TOWN OF PLAINFIELD DESIGN REVIEW COMMITTEE REPORT

CASE NO.: [FDP-21-100](#)

REQUESTED ACTIONS: Final Detailed Plan approval of a 252,747 square foot expansion on the north side of the existing Metro Air Business Park Building 9 with additional trailer parking spaces, loop drive, and automobile parking on a 41.50 acre parcel zoned [Metro Air Business Park, Phase 2 Planned Unit Development](#) within a [Gateway Corridor](#).

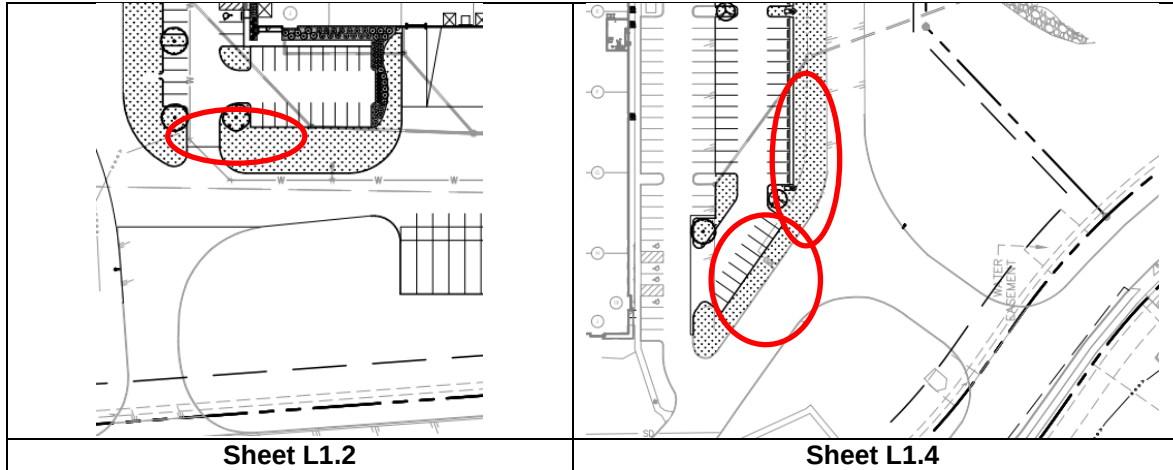
14. **Parking Lot Screening:** **Does not comply—areas shown in illustration need to be screened with shrubs.**
